## BID ADDENDUM

<b>State Project No:</b> FP00000218	<b>PROJECT NAME:</b> Colonial Life Arena Miscellaneous Roof Repairs	<b>ADDENDUM NO.:</b> One  <b>ADDENDUM ISSUE DATE:</b> February 6, 2019
--	---	---

**COLONIAL LIFE ARENA BUILDING ENVELOPE REPAIR**  
UNIVERSITY OF SOUTH CAROLINA  
COLUMBIA, SOUTH CAROLINA  
REI PROJECT #: 18CHS-082

DRAWN BY: RLW  
SCALE: 1" = 30' - 0"  
DATE: 01/07/2019  
DRAWING: XR-101  
SHEET 2 OF 4  
ROOF PLAN

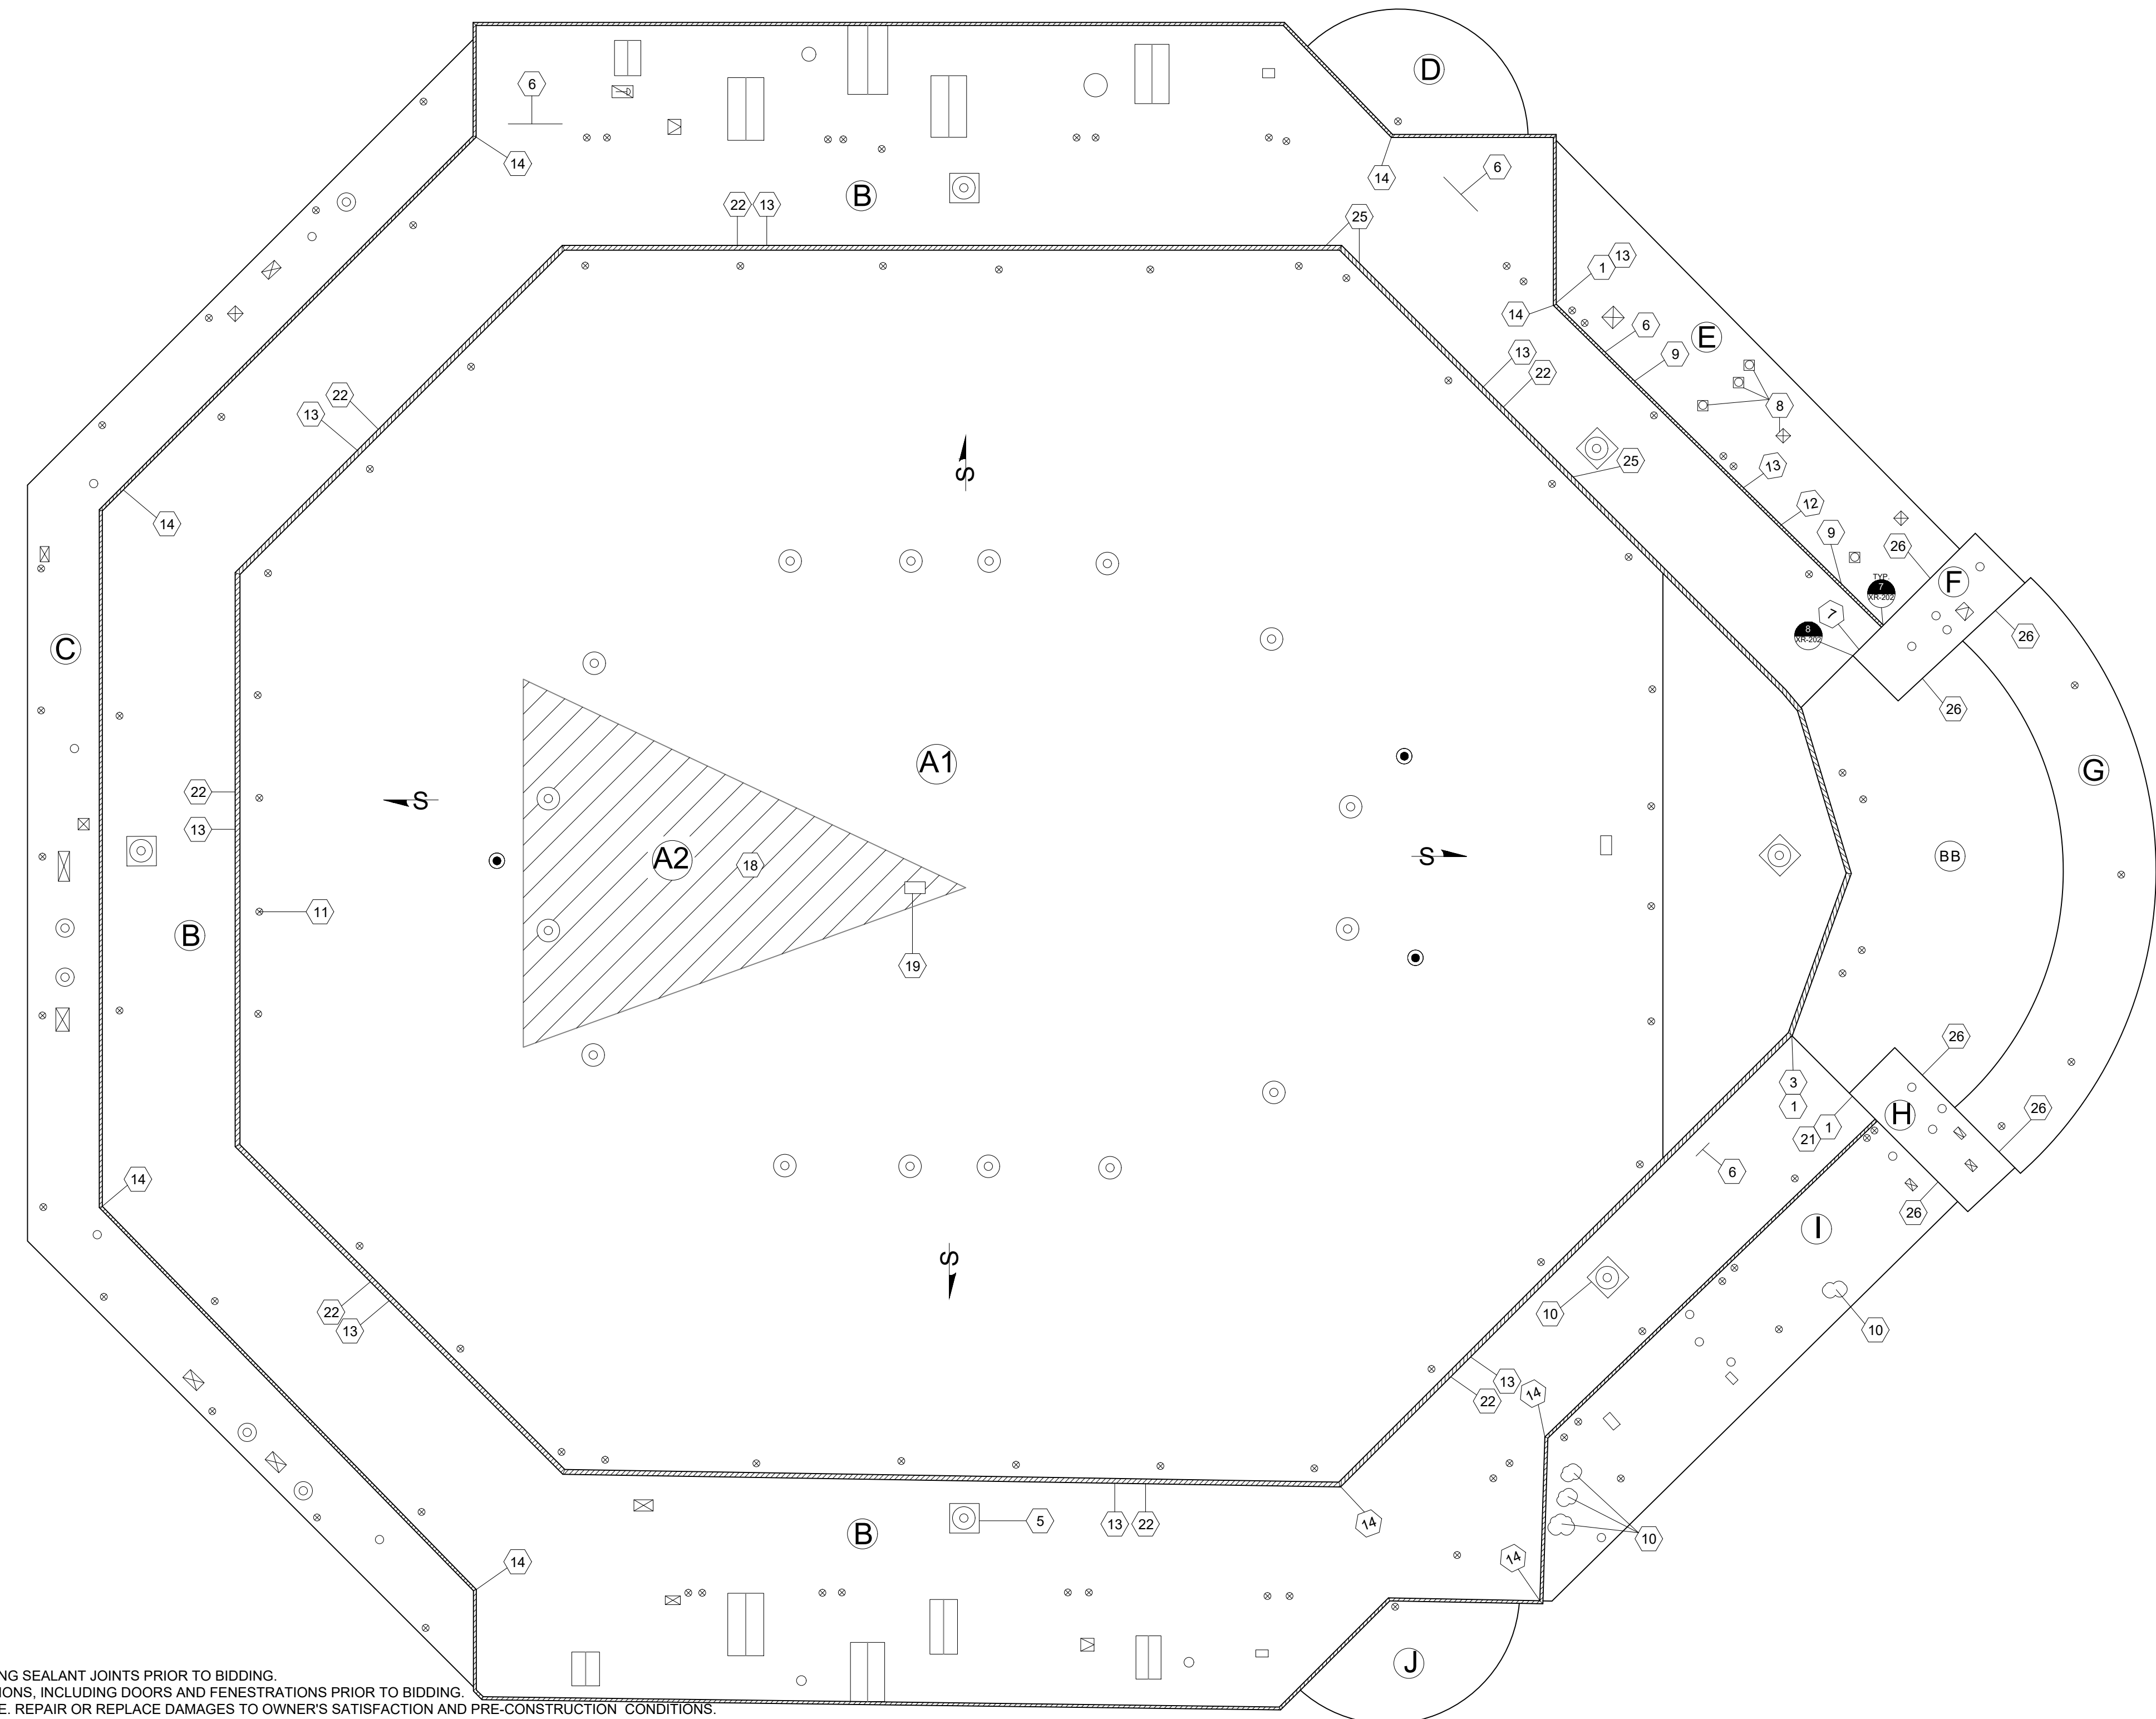
**REPLACE** Drawing XR-101 **WITH** Drawing XR-101 REVISION DATE 02/06/2019.

- A. Application of Fluid Applied Water Repellent where indicated on Drawing XR-101 and as specified in Section 07 19 00 – Fluid Applied Water Repellent.
